TECHNICAL ASSESSMENT DEFICIENCIES

Genwal Coal Company, Inc.

Crandall Canyon Property
PRO/015/032, Emery Country, Utah

TA RESPONSE

• RIPRAP DESIGN @ END OF 54" OUTLET PIPE.—

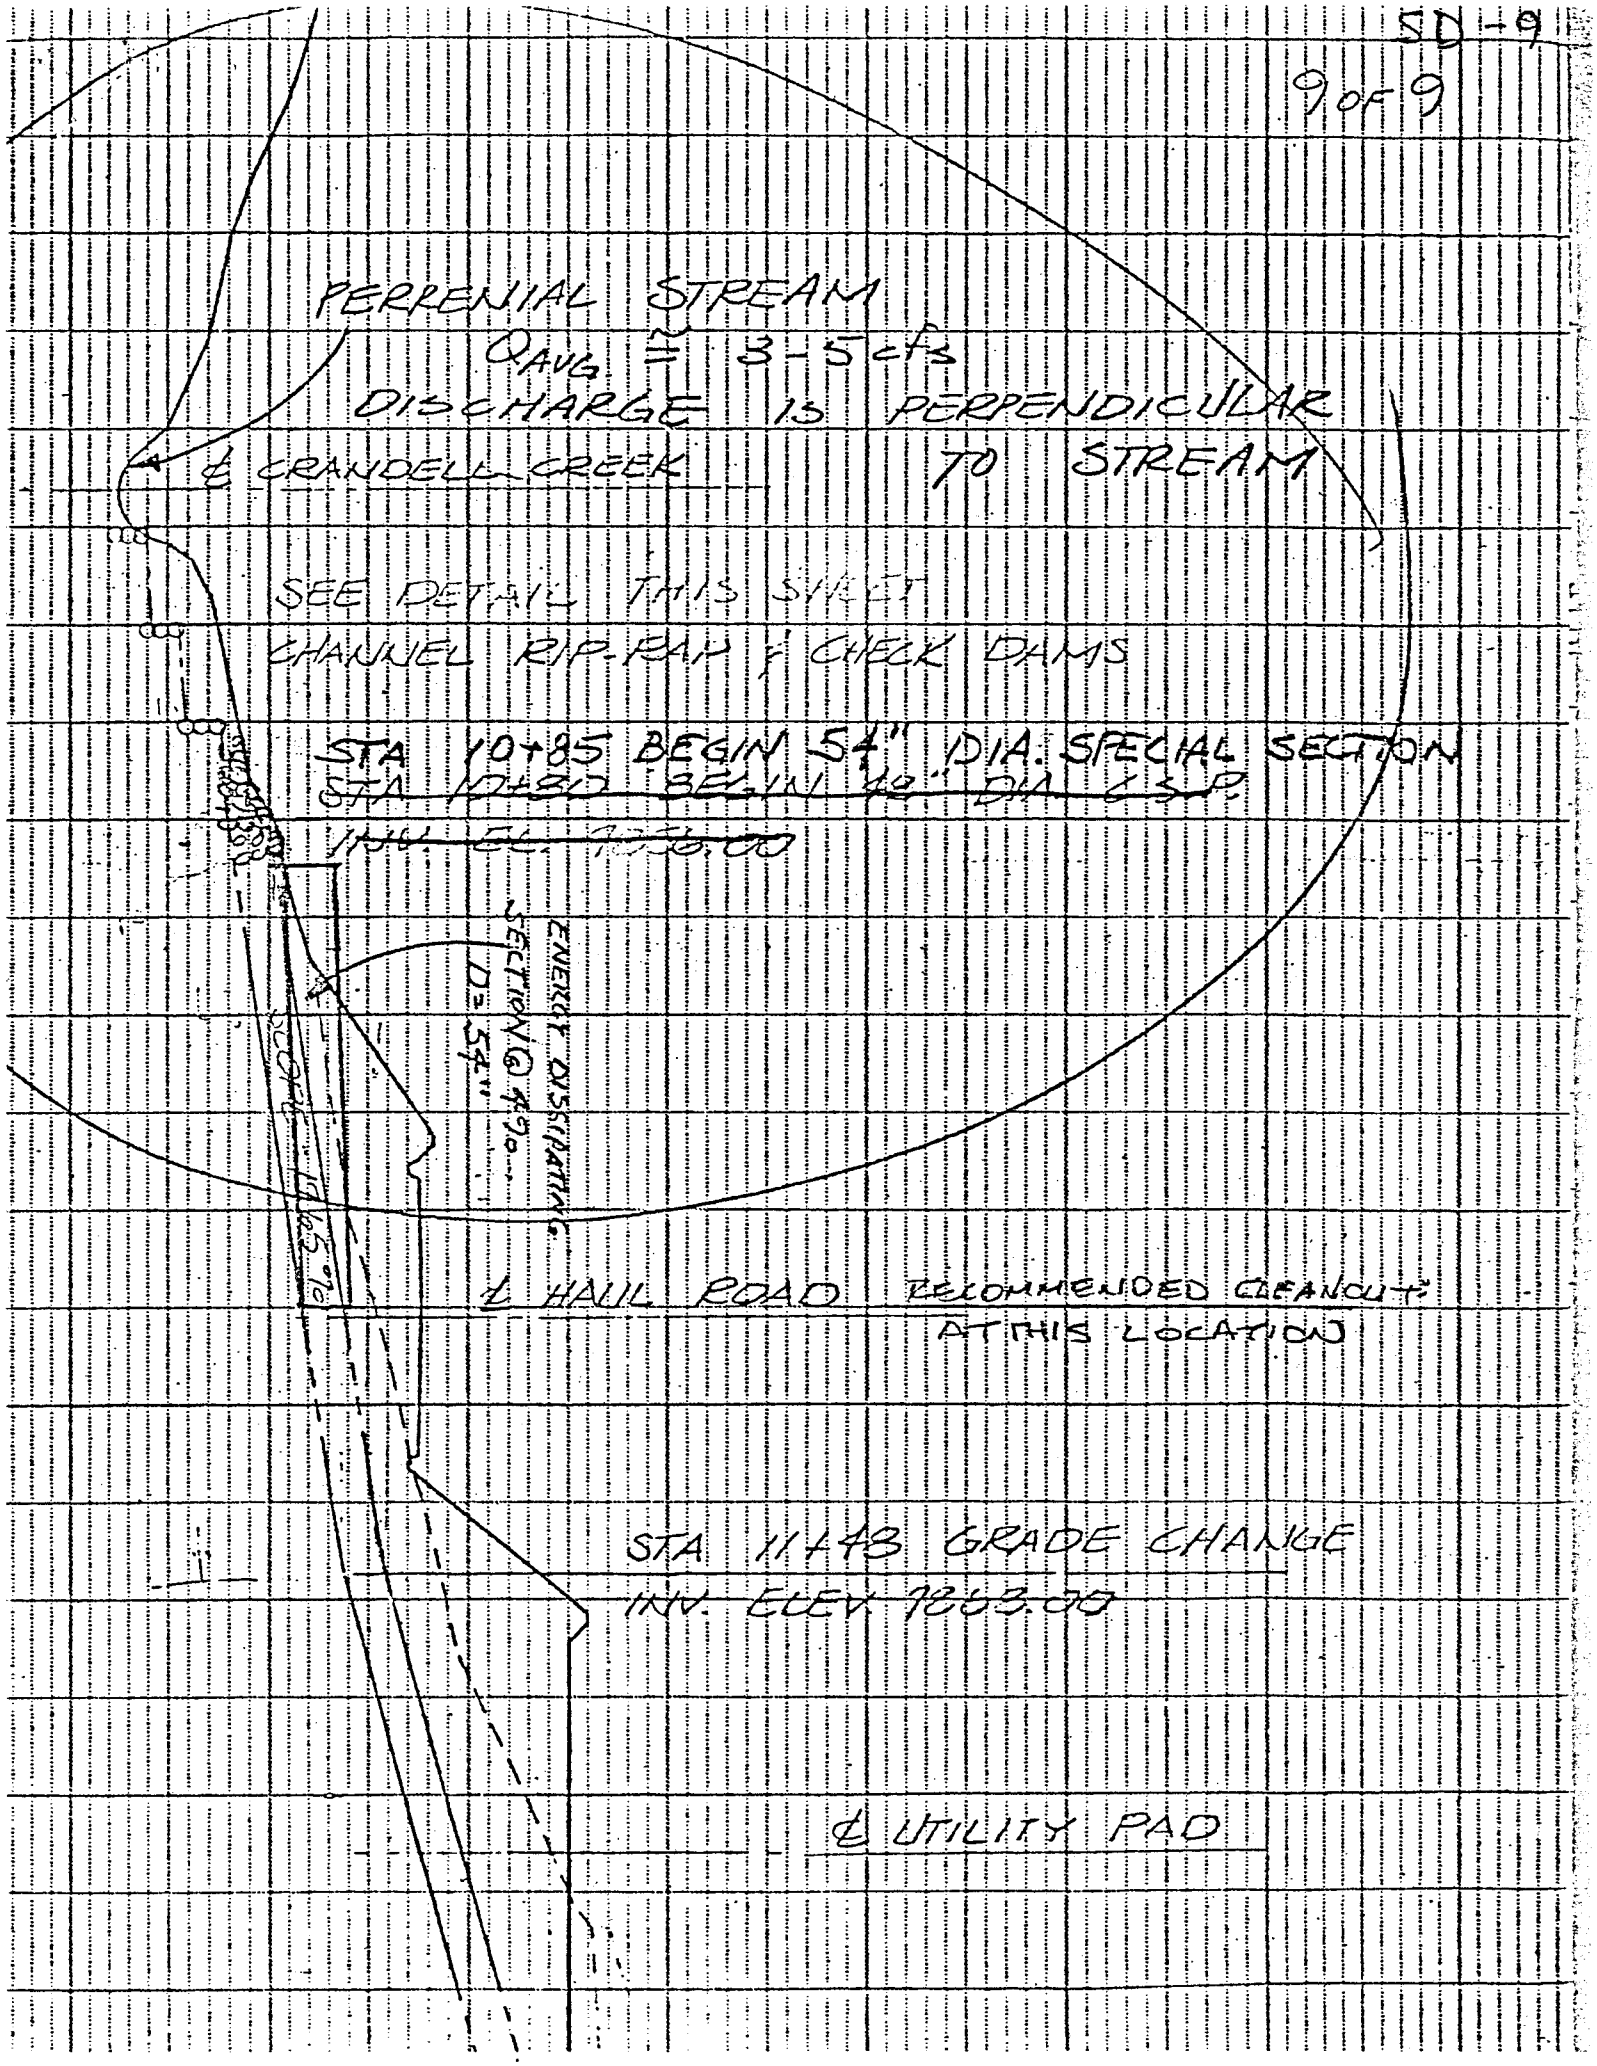
Outlet velocity = 9 ft/sec depth ≅ 2.7 SAY 3'

EITHER ONE WILL WORK. USE AT LEAST 12" OF RIPRAP AND ADD FILTER CLOTH UNDER IT. THE GRADATION SHOWN IN DRWG G01-C-019 WILL ALSO WORK FOR THE 9 Ft/sec, d ≅ 3' CONDITIONS.

* CUT-OFF-WALL HEIGHT WILL DEPEND ON THE CREEK'S SCOUR. WE DO NOT HAVE INFORMATION ON THIS BUT BE CONSERVATIVE.
